29 June 2015

**RE: DEVELOPMENT APPLICATION REF:LDA 2015/0031, SHEPHERDS BAY STAGES 8 AND 9, ADDRESS: 116-122 BOWDEN STREET, MEADOWBANK**

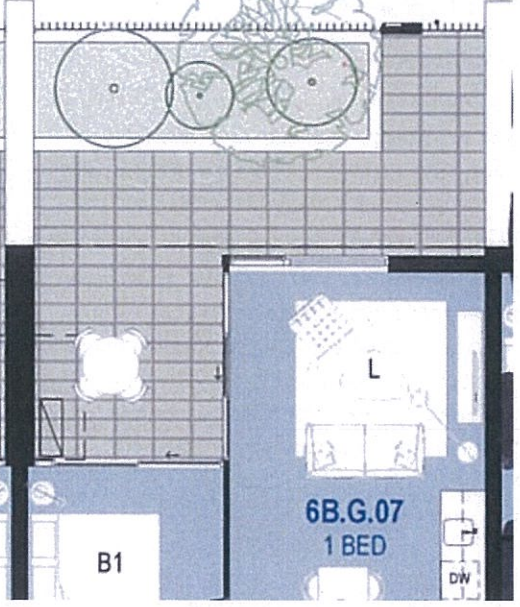
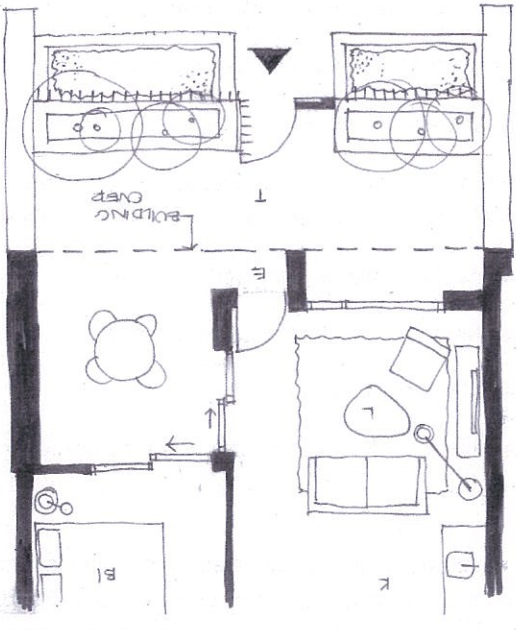
| Council Issue                                                                                                                                                                                                                                                                                                                                                                                                                           | Response                                                                                                                                                                                                                                                                                                                                                                                                                                                                          |
|-----------------------------------------------------------------------------------------------------------------------------------------------------------------------------------------------------------------------------------------------------------------------------------------------------------------------------------------------------------------------------------------------------------------------------------------|-----------------------------------------------------------------------------------------------------------------------------------------------------------------------------------------------------------------------------------------------------------------------------------------------------------------------------------------------------------------------------------------------------------------------------------------------------------------------------------|
| <p><i>The Panel encourages this treatment to be repeated along the though site link to the eastern boundary (Building 8) and the northern ground floor address of Building 9B.</i></p> <p><i>In all cases where a ground floor unit has an individual address, it should be configured as formal dwelling entry (rather than as a secondary, purely private address).</i></p>                                                           | <p>better distinction to the front door. An example for Stage 6 being Unit 6B.G.07 is illustrated below:</p>  <p>Existing plan</p>  <p>Proposed plan</p>                                                                                                                                                     |
